Changes to BLM thresholds during TS2

LHC-BLM-ECR-0038

19th BLM Thresholds WG Meeting
25/08/2015

THRI_7_TCP

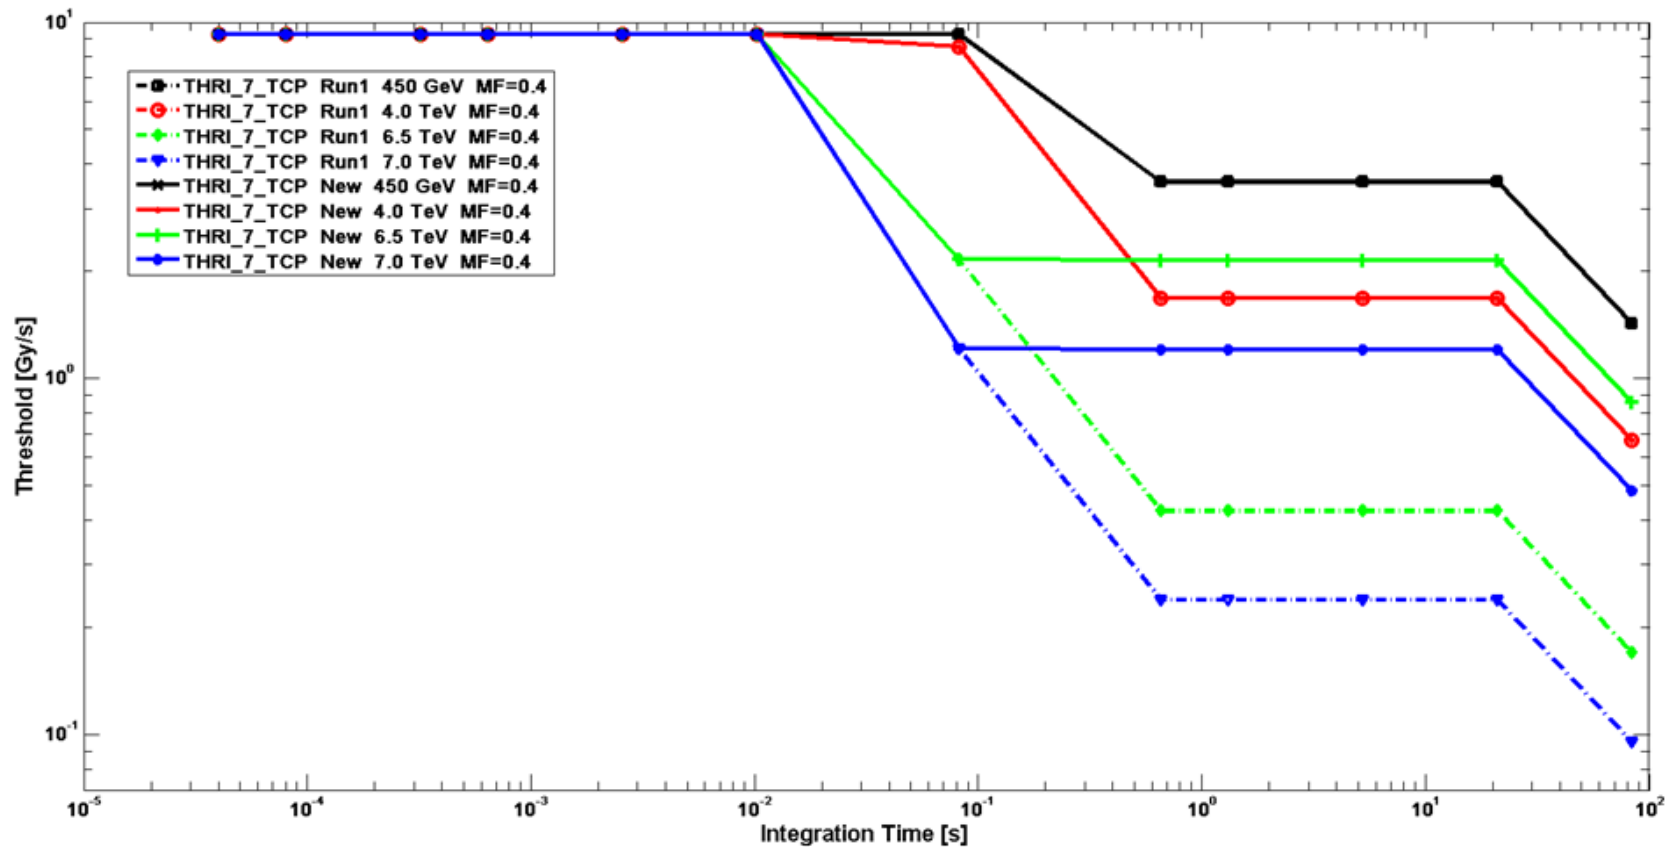
- THRI_7_TCP; THRI_7_TCSG and THRI_7_TCSG_F5; THRI.06_7_AB_TCLA, THRI.06_7_CD_TCLA and THRI.07_7_AB_TCLA families
- Ad-Hoc factor correction to RS09 and fix to RS09 to get FT at top energies

THRI.IP3.P1_MQTL

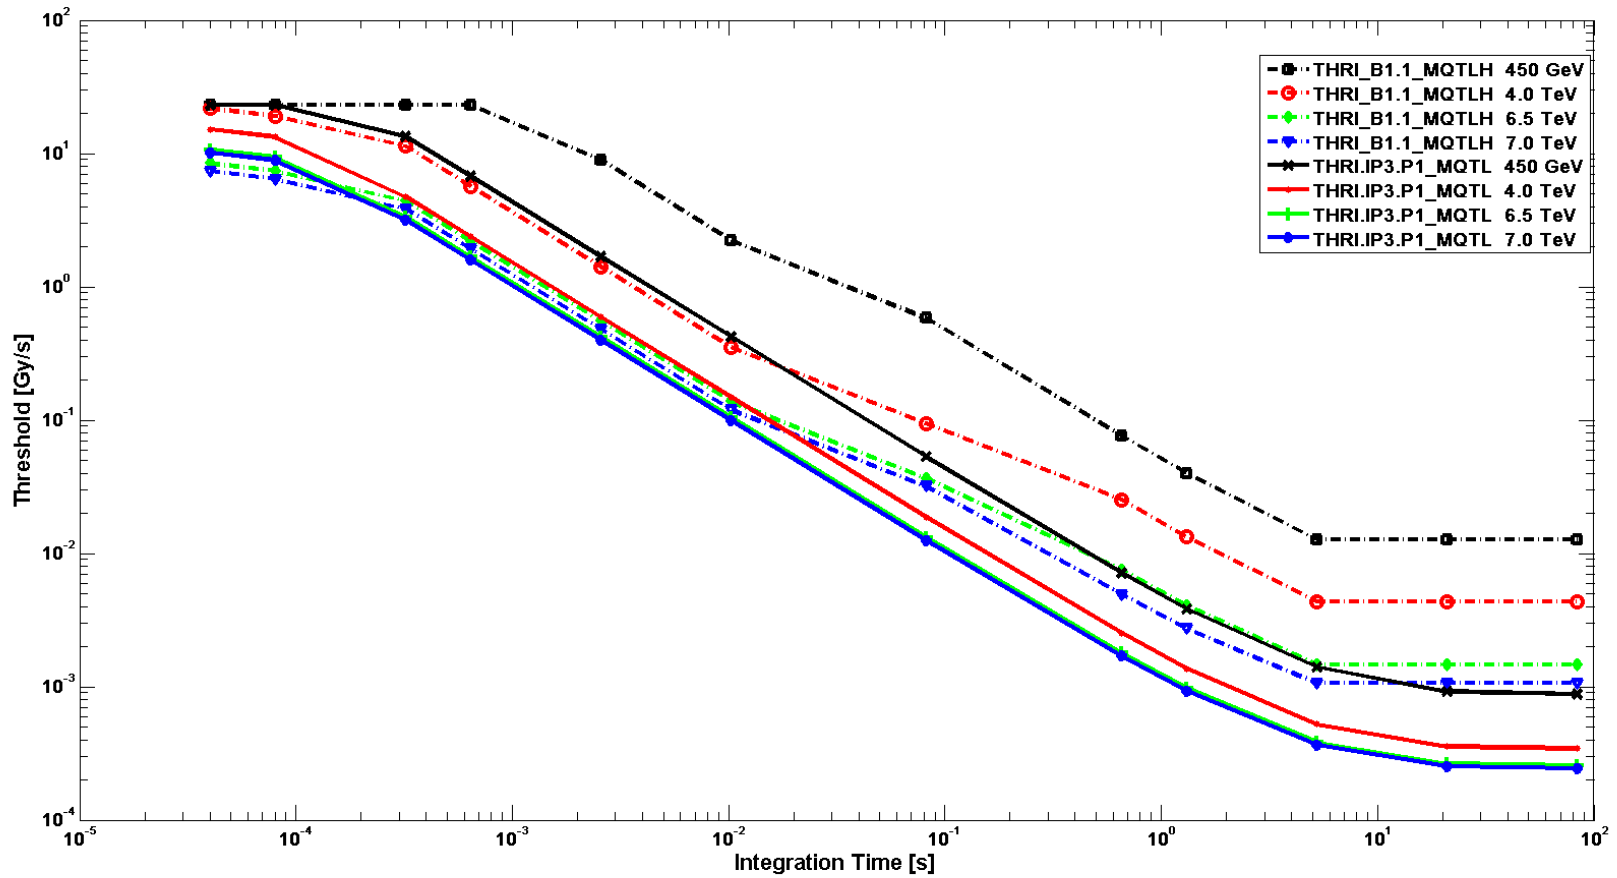
- New threshold models were calculated during LS1 but are not yet implemented to some of the monitors in the long straight section
- Since modifications are required to MQTL monitors in IR7, it was decided to introduce the new models to IR3 monitors at the same time
 - Main changes to position 1 and 2 monitors
 - MF at 200 kW from 1.0 to 0.4 and 1.0 to 0.1 respectively
 - Position 3 monitors will remain in a set to MAX family

THRI.LS.P1_MQY_FT

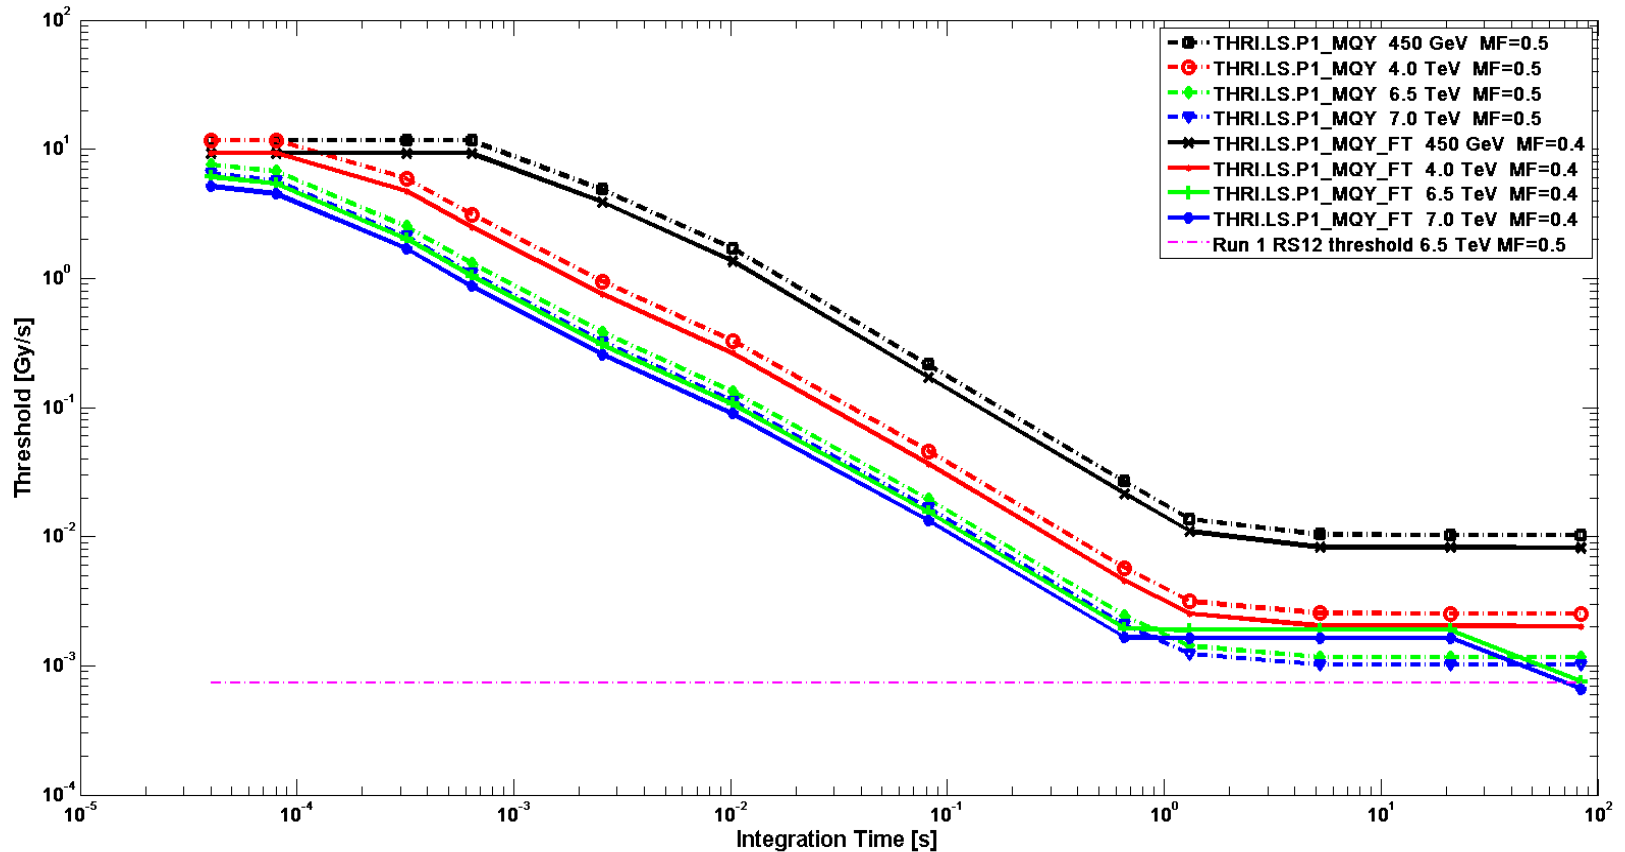
- For the MQY monitors, new thresholds had already been implemented
- FT correction required only for P1 monitors in IR6
 - MF will be changed from 0.5 to 0.4 at 200 kW

THRI.IP3_MQW

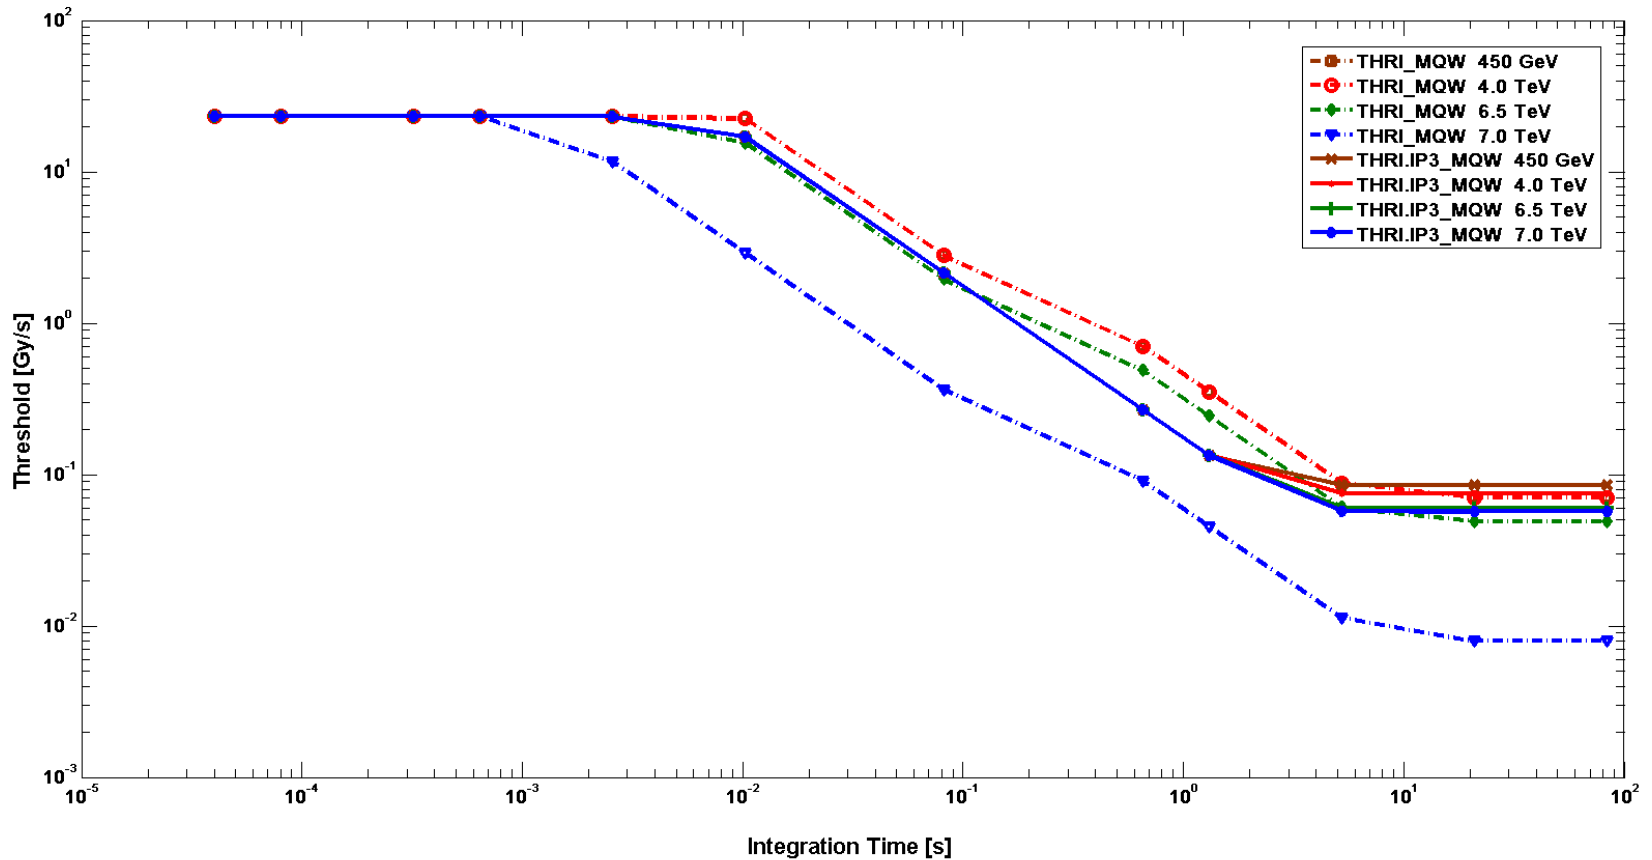
- Similarly to MQTL thresholds, new models to MQW monitors had been calculated but not yet implemented

THRI.LS.P1_MQY_WS

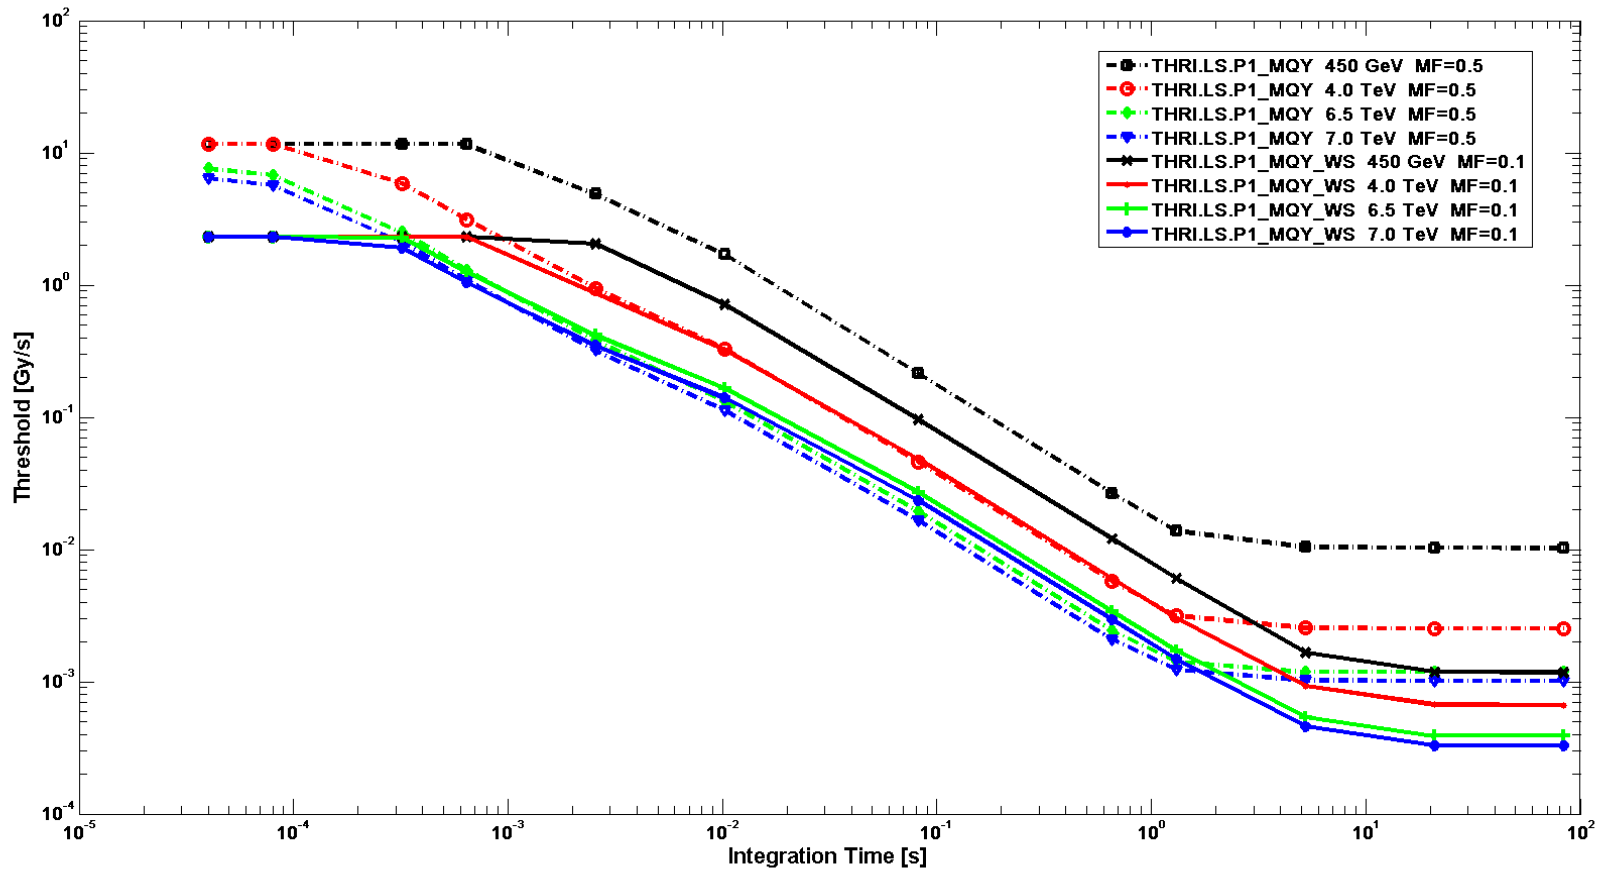
- Only cell 5 MQYs were assigned to a dedicated WS families
- From measurements it was seen that also some cell 6 monitors should be in the WS families
